REPORT TO THE CALGARY PLANNING COMMISSION

<b>DEVELOPMENT PERMIT</b>	<b>ITEM NO: 01</b>	
	CPC DATE:	2012 December 06
	DP NO:	DP2008-3012

**PROPOSAL:**  
Seventeen (17) storey commercial development (office) with retail uses at-grade.

# KEYNOTE - TOWER 4 SITE PLAN

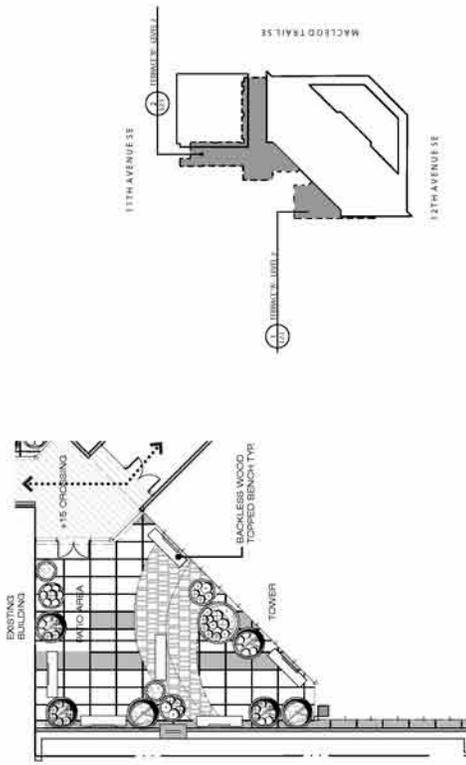
13. Indicate the existing street light along Macleod Trail SE and the distance between the street light and the proposed boulevard trees on landscape plan L1.1 and site plan. A minimum of 4 metre setback is required as per Parks Development Guidelines and Standard Specifications – Landscape Construction (current edition). Adjust tree spacing and/or the number of proposed trees accordingly.

south +15 terrace 'B' landscape plan

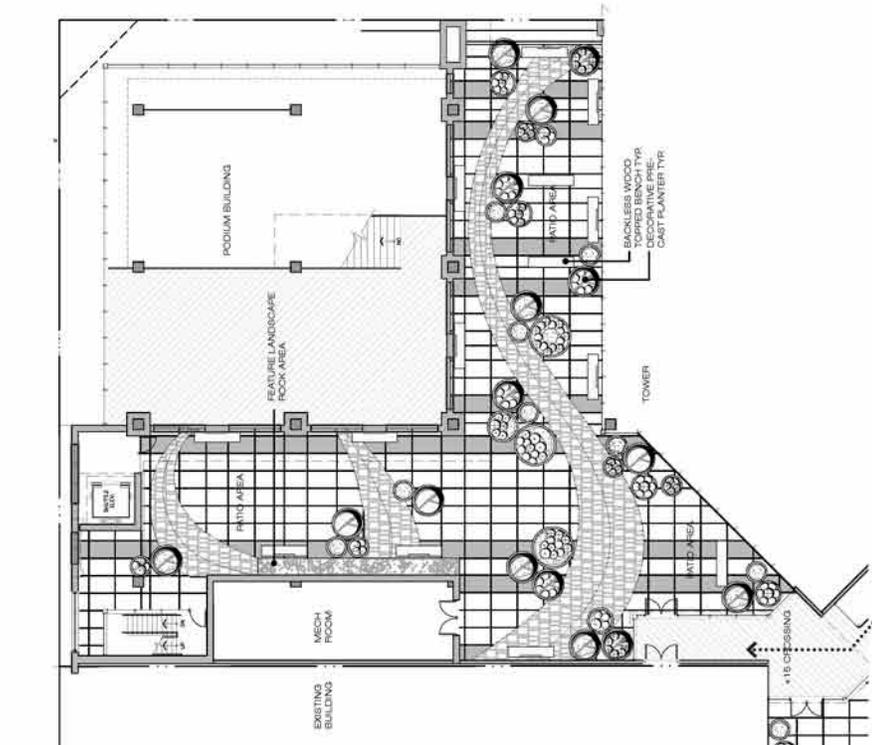
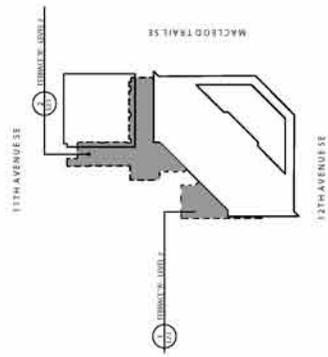
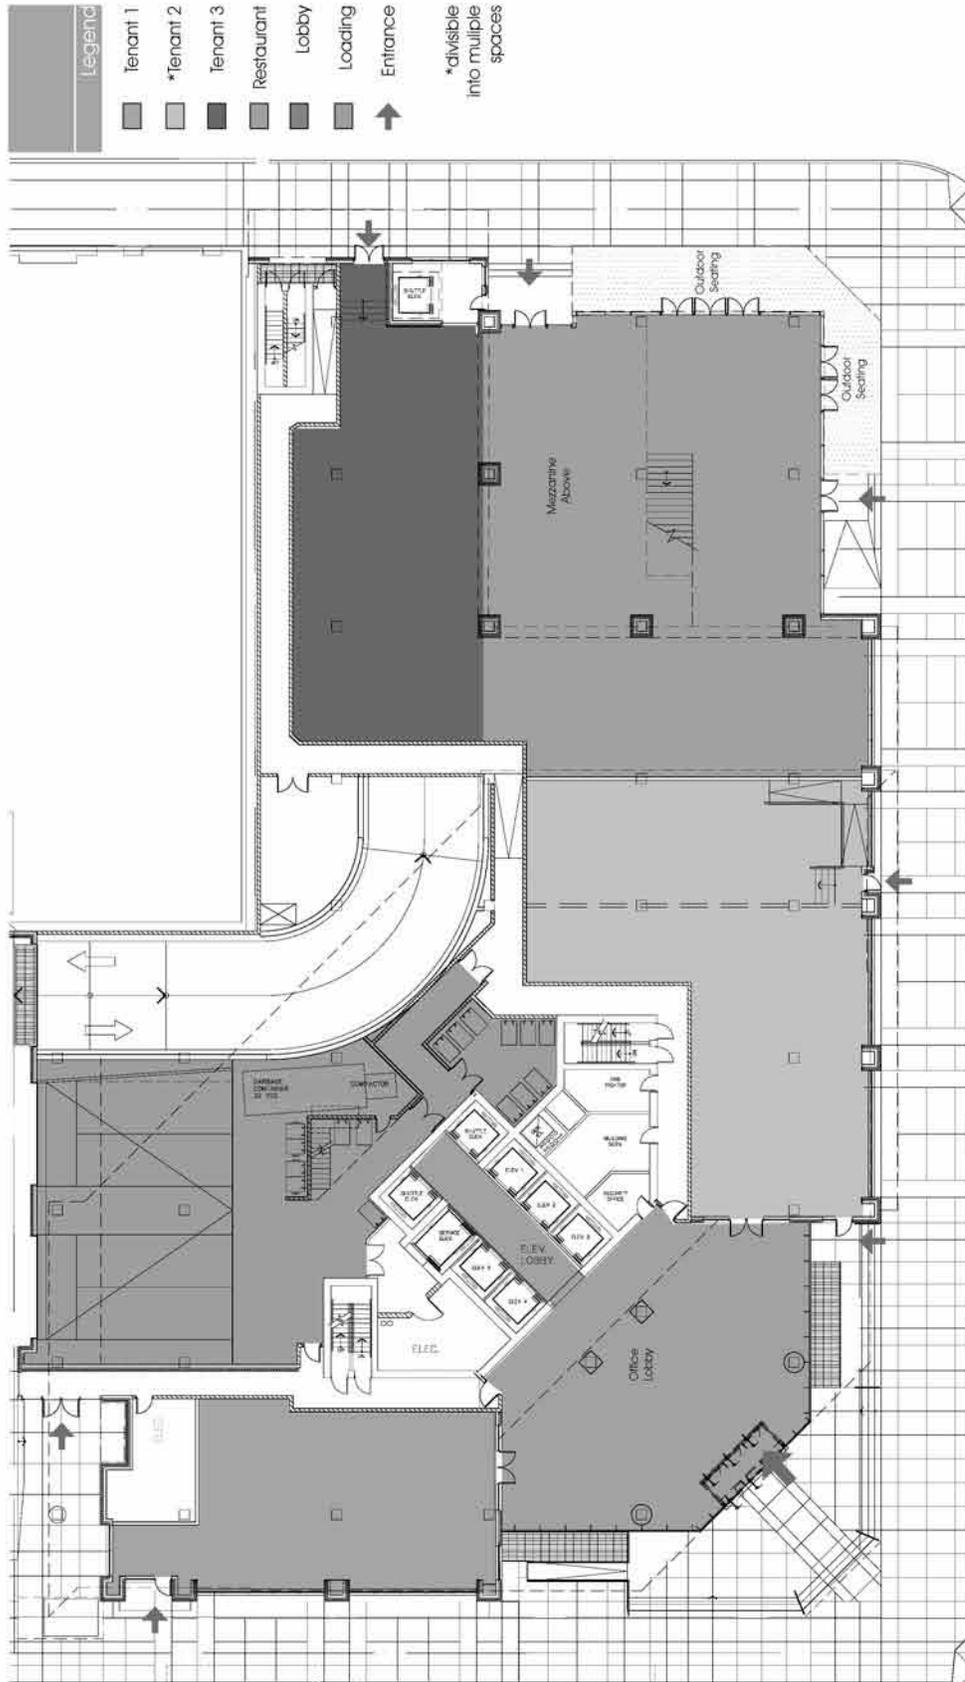
- (8) ***The Panel is concerned that the Plus 15 landscape will be challenged by a lack of sunlight. It also notes that the patios on 11 Avenue and on Macleod Trail SE are located in the least sunny areas and may have difficulty in providing a comfortable outdoor environment.***

***Applicant's Response:*** Sunlight quantity is a concern, and low light plantings will have to be selected to ensure viability.
